Job Name	Drake House, Langstone, Newport	Job Number	1228	Date	14.02.25
----------	--	------------	-------------	------	-----------------

Site Report – Final snagging

The above site was inspected on the 14th February 2025 at 12.00pm by Dan Patterson of dp landscape architecture [DPLA]. This report assesses the completed work against DPLA drawing number 1228.01.

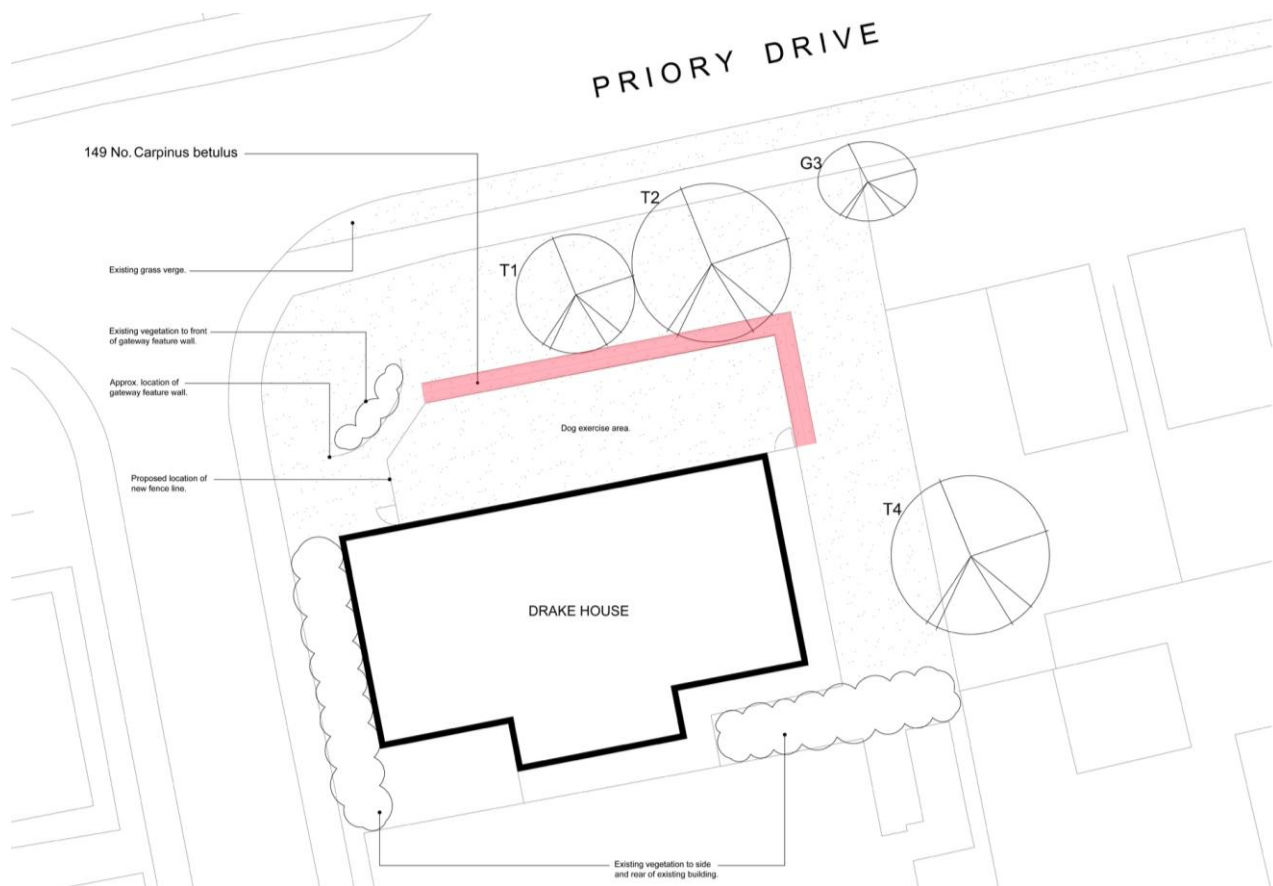
There is a very narrow strip of grass between the hedge and the fence line. See photographs below. It would be beneficial to remove / kill off this grass to avoid any future maintenance issues. The gap should be filled with bark, up to the fence line.
